Based on our discussions on site at 332R Mowbray River Rd, I would like to formally request amendments to decision notice reference number 8/30/121(3964031).

Subject Engineer's Inspection Report

Access Road on Lot 4 RP865070 at 332R Mowbray River Road, Mowbray.

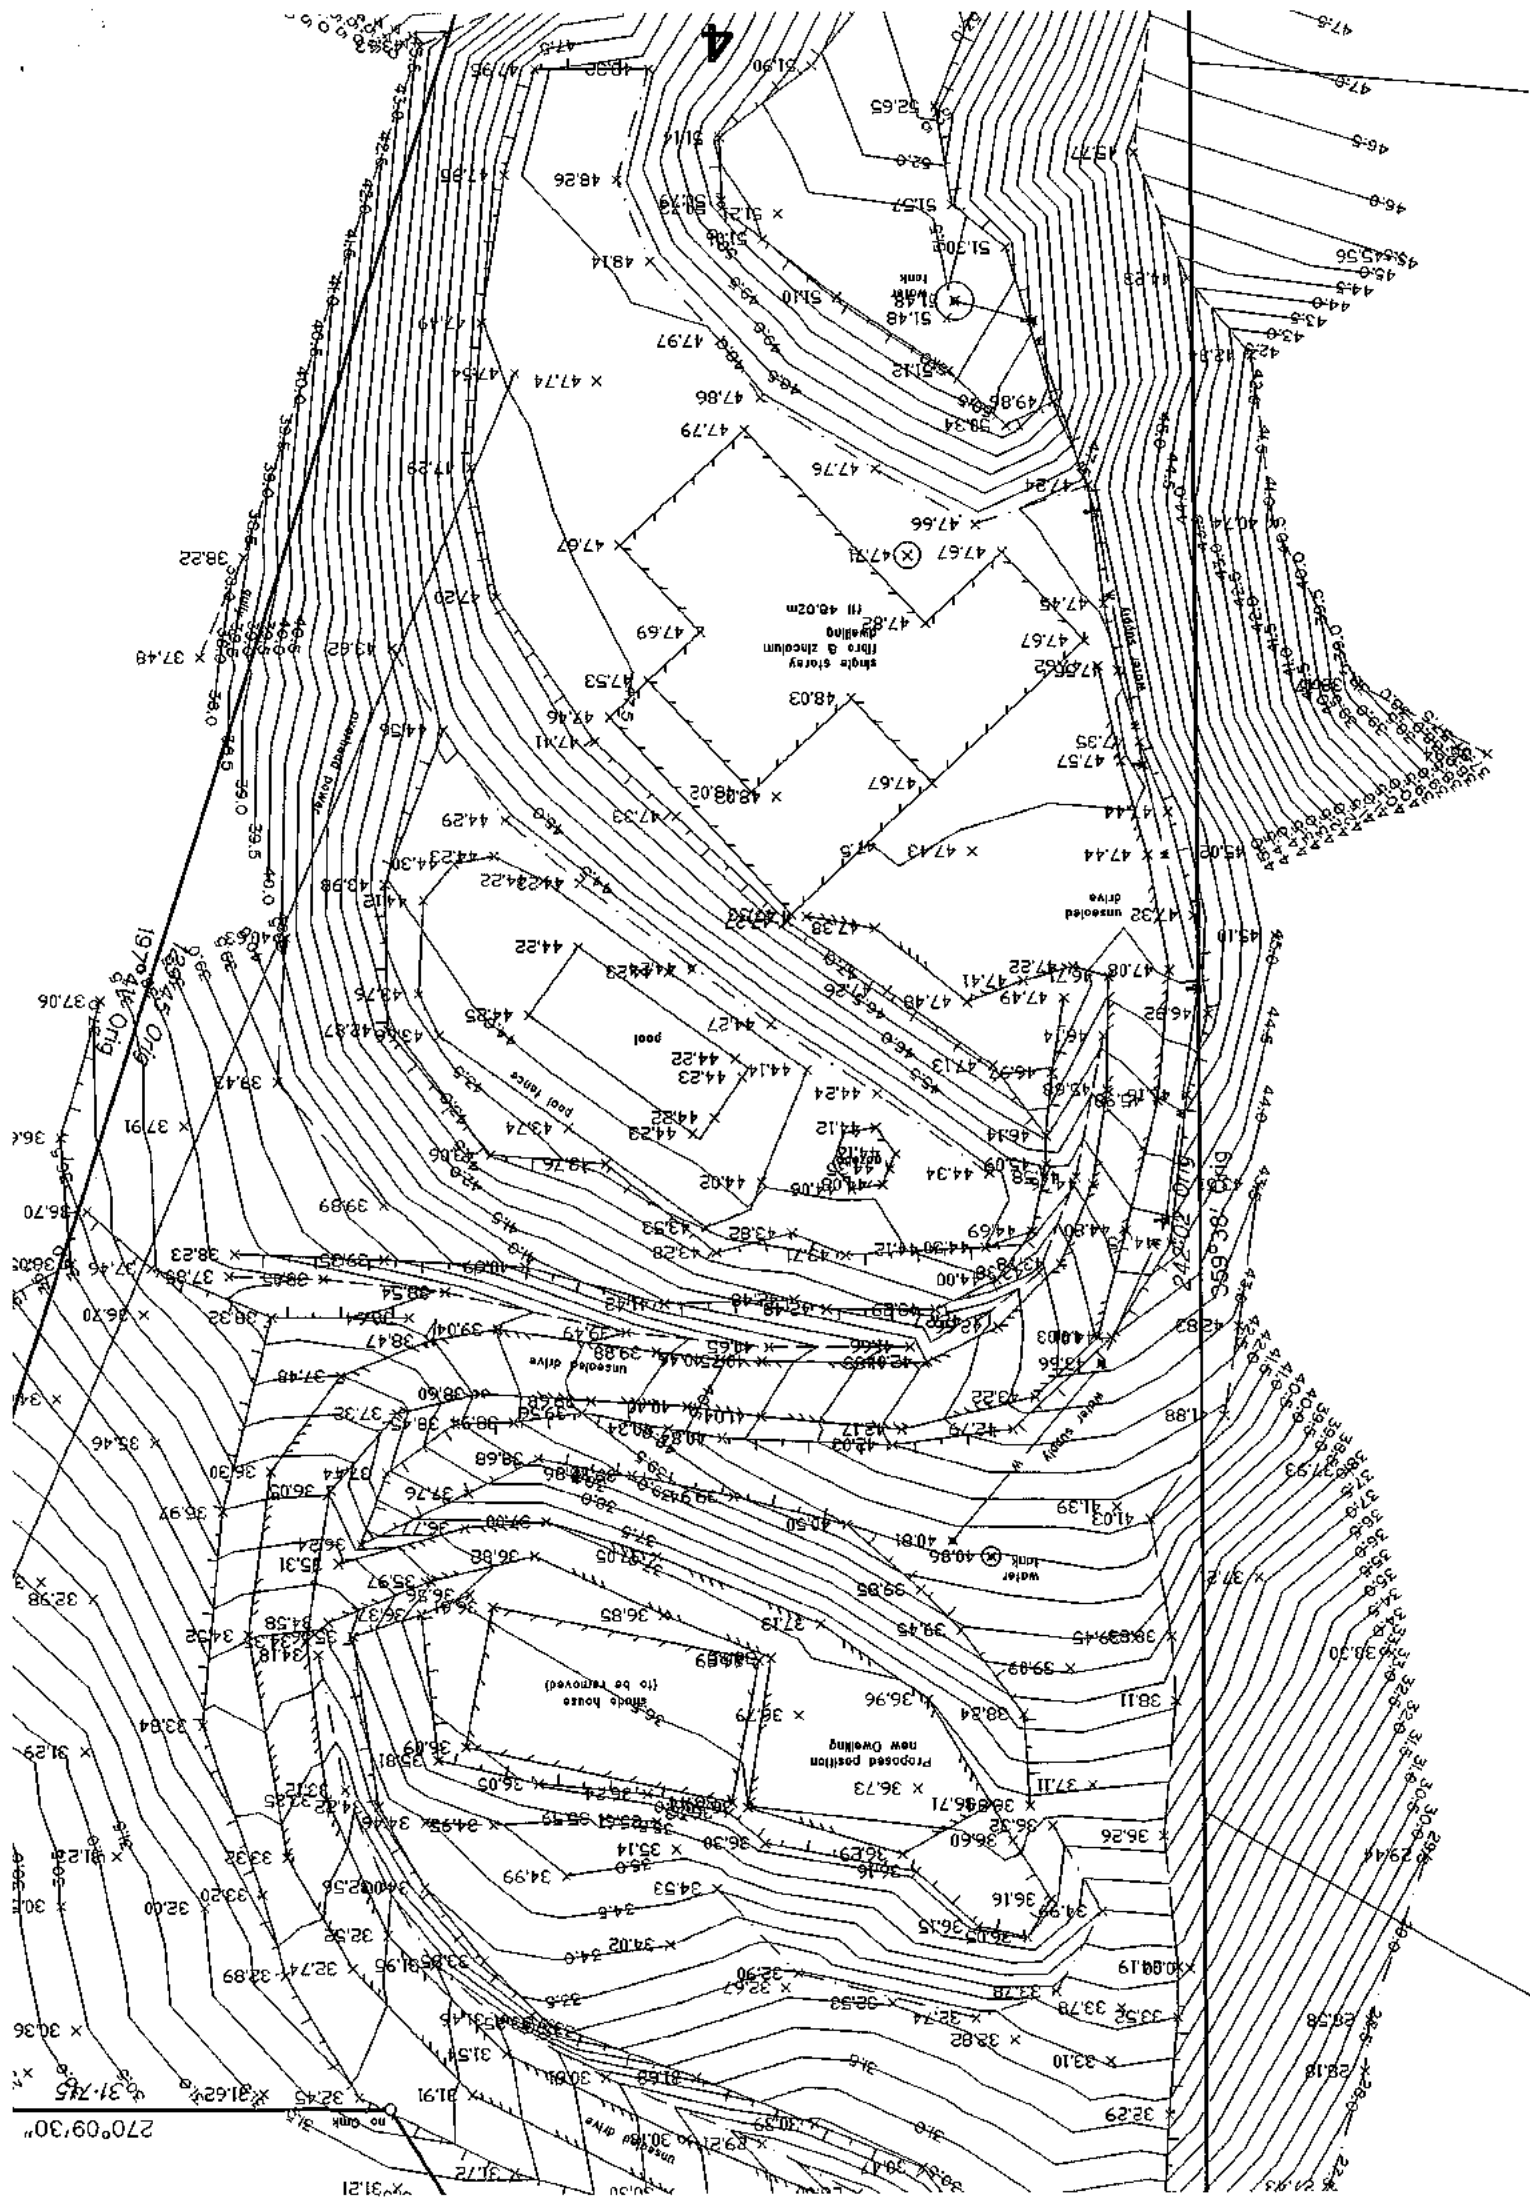
Condition 10. Plan of Drainage Works

No local drainage study should be required as it is not proposed to alter the existing drainage regime. It is estimated that a very small surface area of driveway will naturally drain, as it has done for the past 20 + years, not impacting on the lower already established lot. Discussions between Peter Dutailis and Neil Beck have indicated a desire for some large drainage rocks to be added to the end of the open drain on one corner to ensure correct drainage into the natural formation of the water ways. Concreting a spoon drain was discussed and Peters advise was that this would increase velocity and allow for water to possible rutt away at the natural lay of the land, it could also course water to run under the concrete changing the flow of the water and the existing system that has proved to work very well for 20+ years. I ask for an amendment as the proposed reconfiguration of the lot will not alter or interfere with the existing stormwater drainage and it will not increase flows, concentration or diversion of flows.

Condition 15. Geotechnical Report

The nature of the earthworks required is going to be little to none. It is not sufficient as to require a geotechnical assessment. The proposed building pad is long standing(20+ years) and stable.
